Docket No. 50-247

The staff has completed its review of your evaluation of the design differences. We find your design acceptable. The enclosed SER documents the basis for those items that required additional information during our review.

UPDATED EVALUATION OF DIFFERENCES BETWEEN INDIAN POINT UNITS 2 AND 3

SIMPLIFIED DIAGRAM OF INDIAN PAINT UNIT 3 120VOLT AC INSTRUMENT DISTRIBUTION SYSTEM

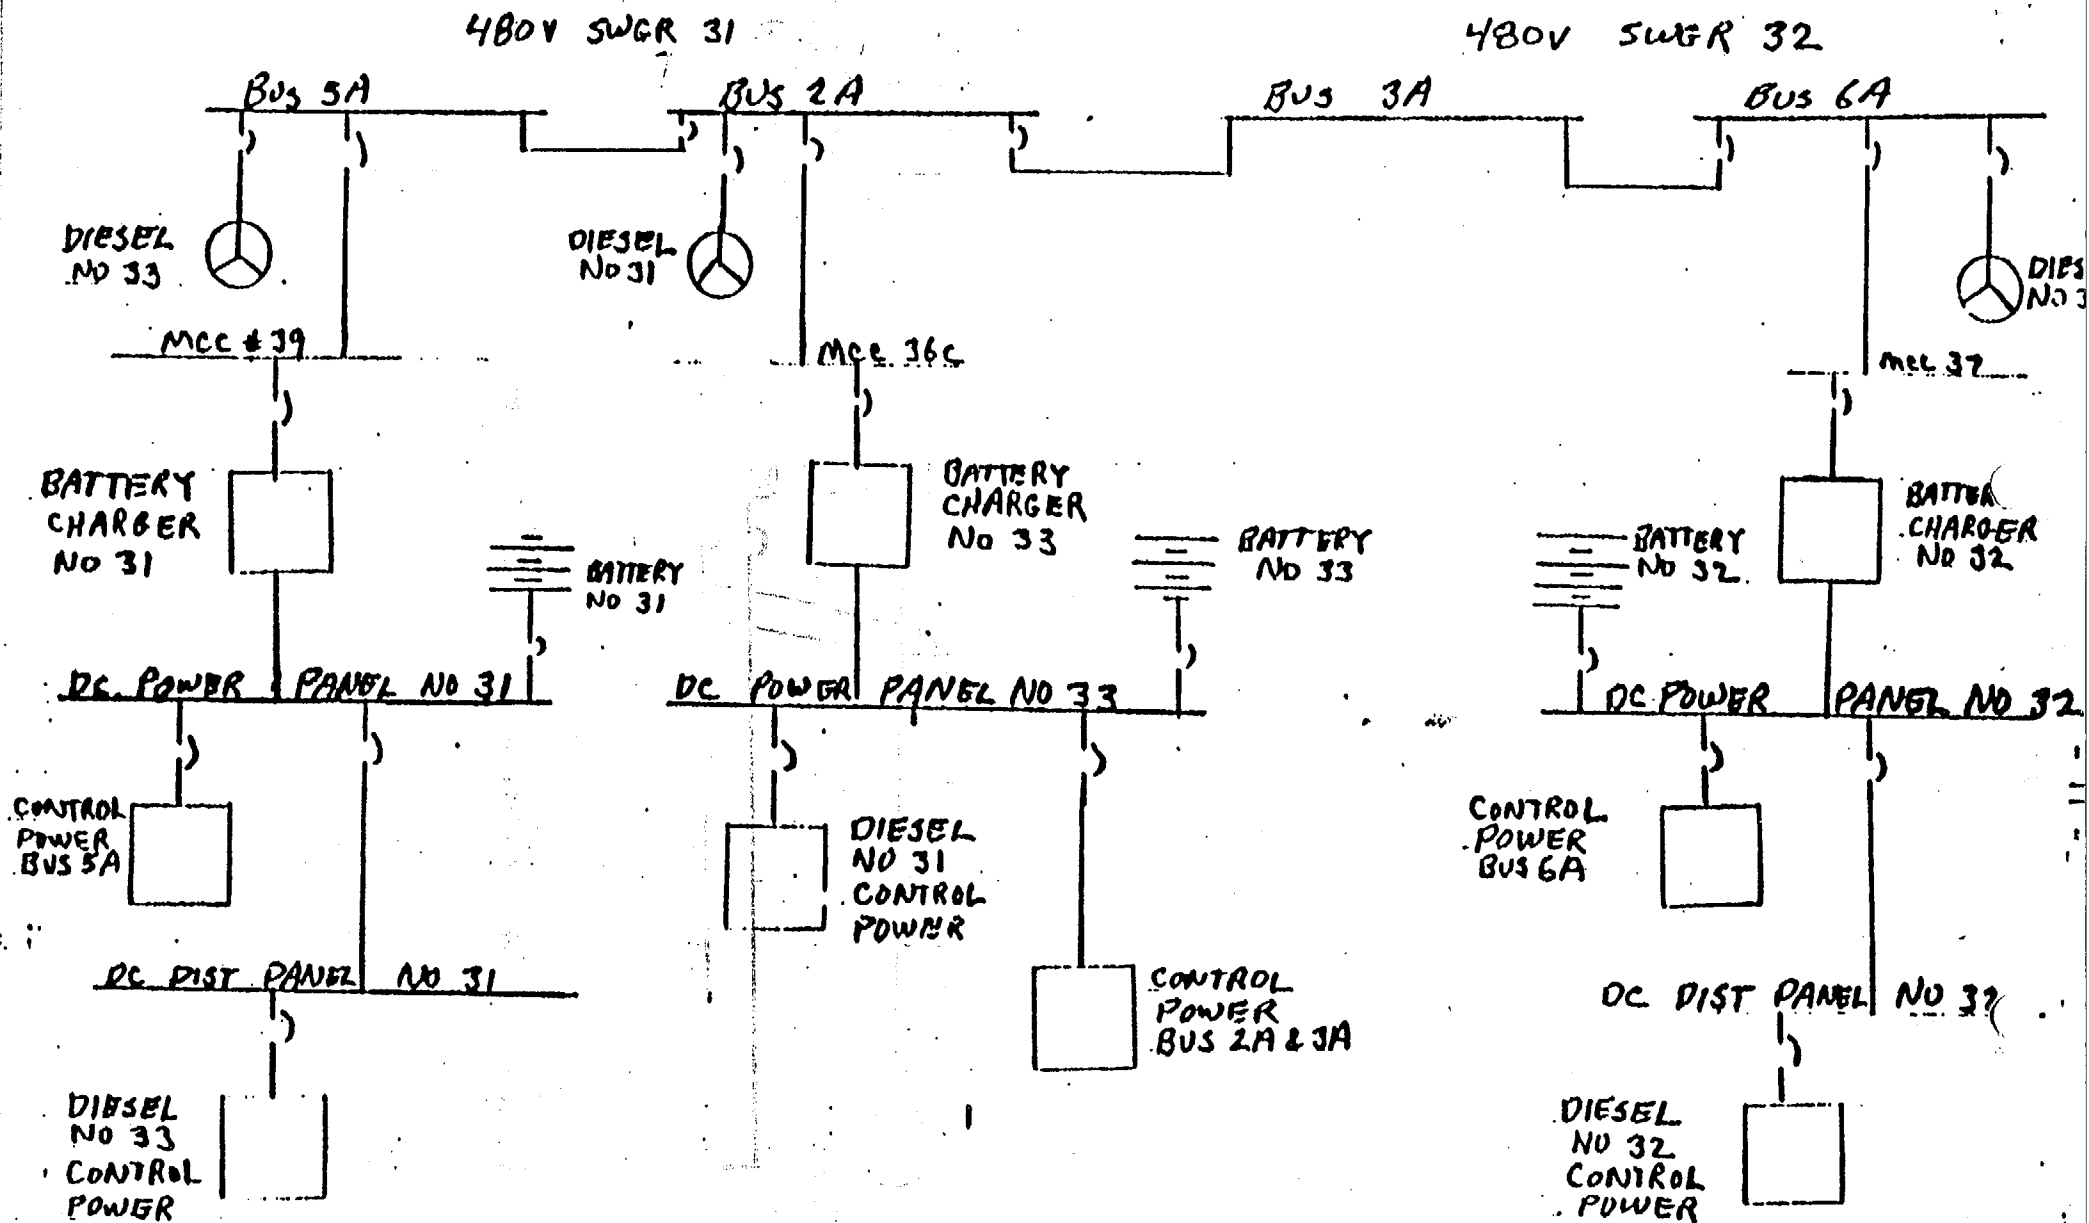
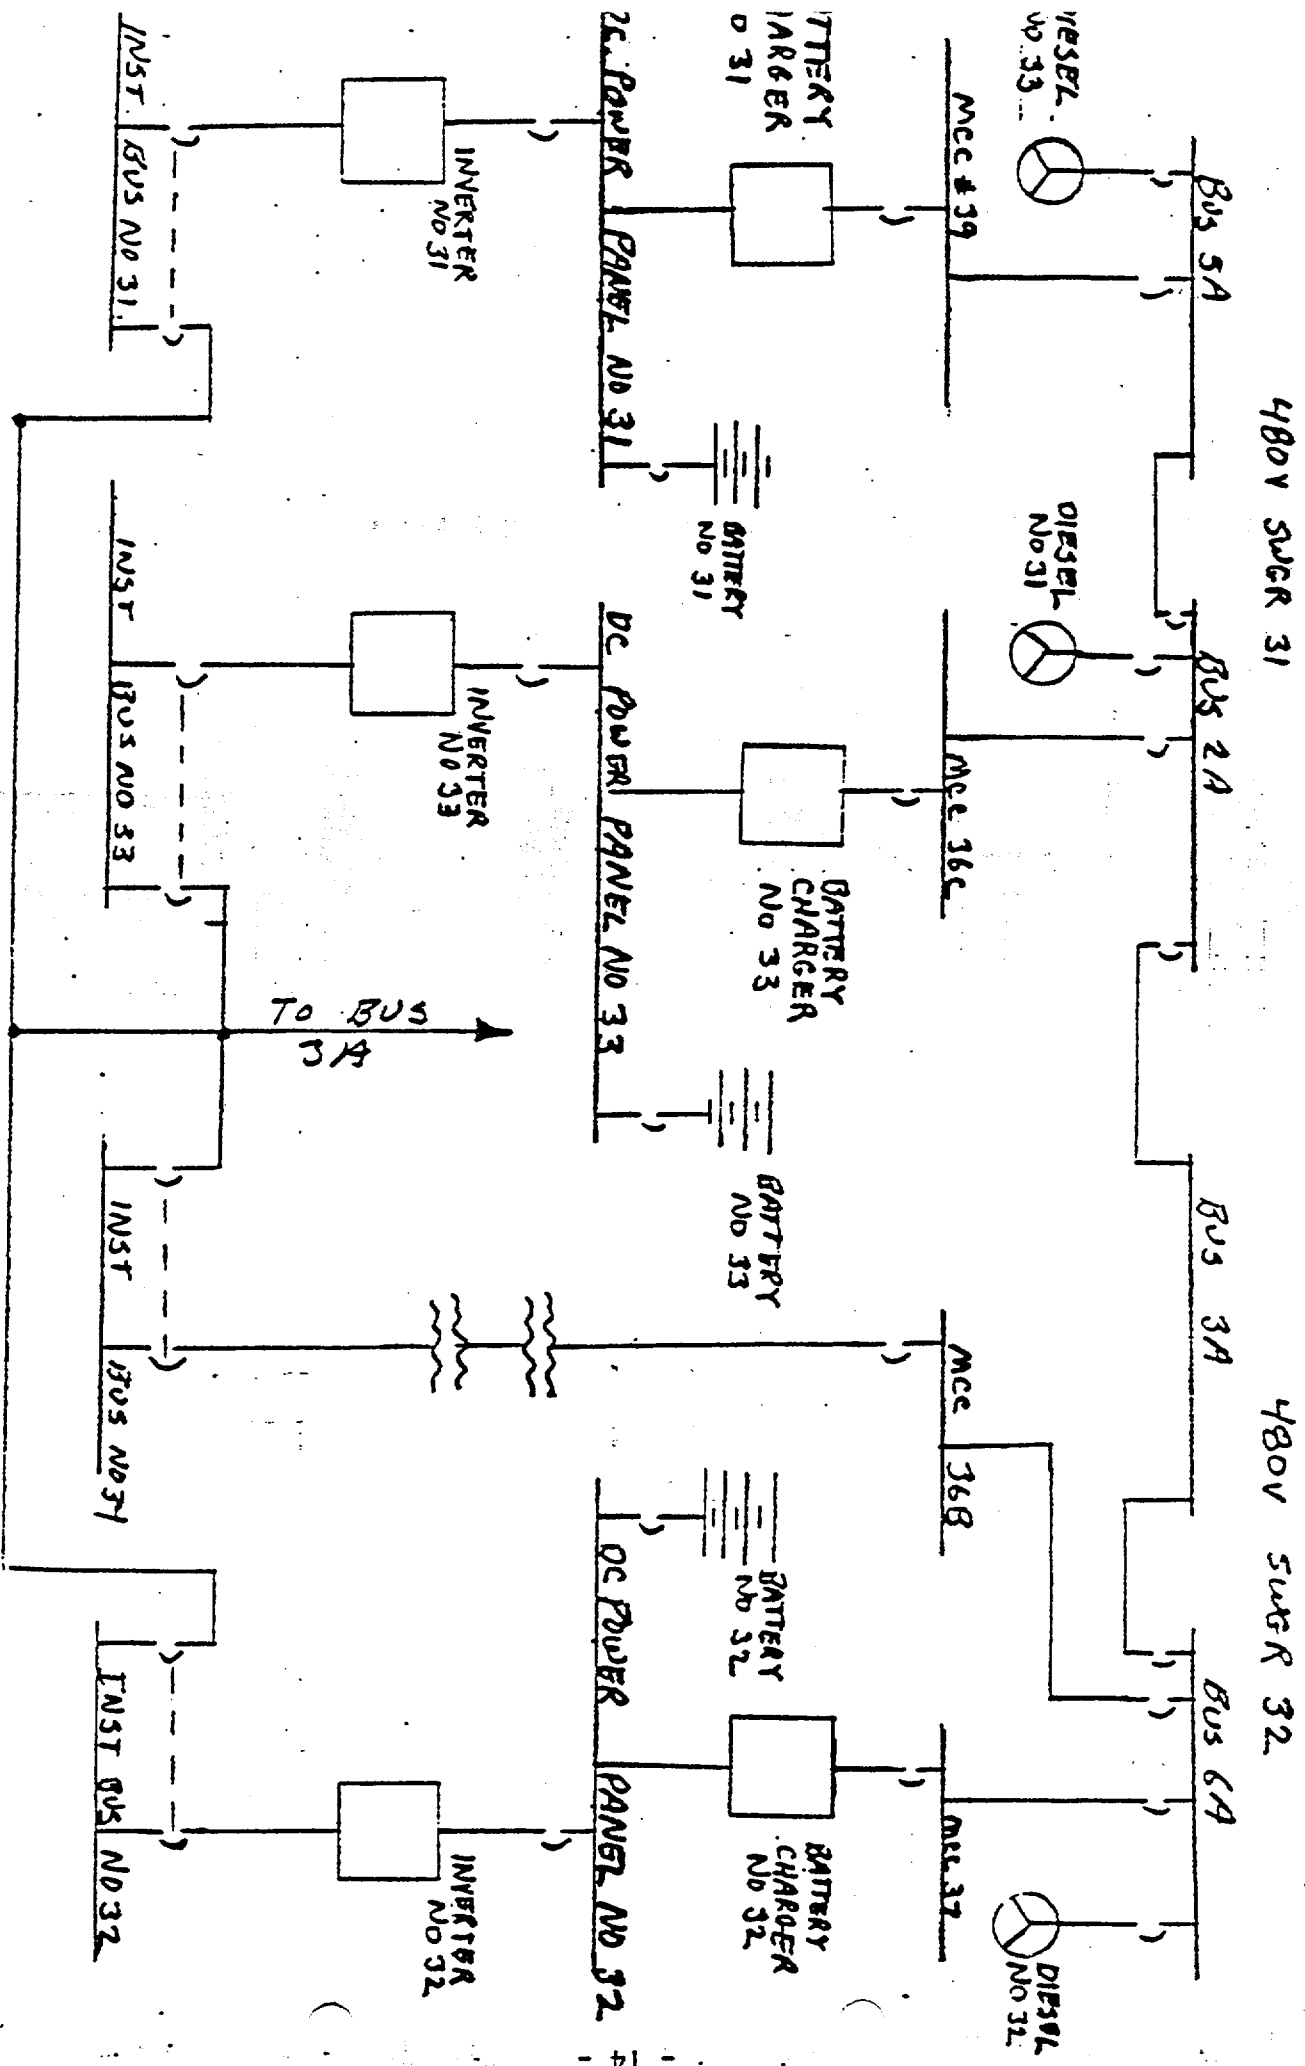
The Unit 3 design, shown in Figure 5, is being upgraded to power all four instrument buses from separate battery banks and inverters. With all four instrument buses being powered from separate batteries and inverters, the Unit 2 and Unit 3 design difference will be eliminated except for one remaining difference between Unit 2 and 3. Unit 3 has a single alternate source of backup AC power to all instrument buses while each instrument bus at Unit 2 has its own backup AC power source.

In justification of this remaining difference, the licensee stated that both Unit 2 and the proposed Unit 3 designs meet present criteria.

We disagree with this justification. The single backup AC power source for the four instrument buses in Unit 3 with no restrictions on number of buses that can be simultaneously connected or definitive limiting conditions for operation does not meet present criteria.

By letter dated May 27, 1982, the licensee indicated that the Indian Point 3 Technical Specifications permits only one of the four 118 VAC vital instrument buses to be supplied from the backup AC power source during unit operation. This Technical Specification limitation meets current staff requirements and is acceptable.
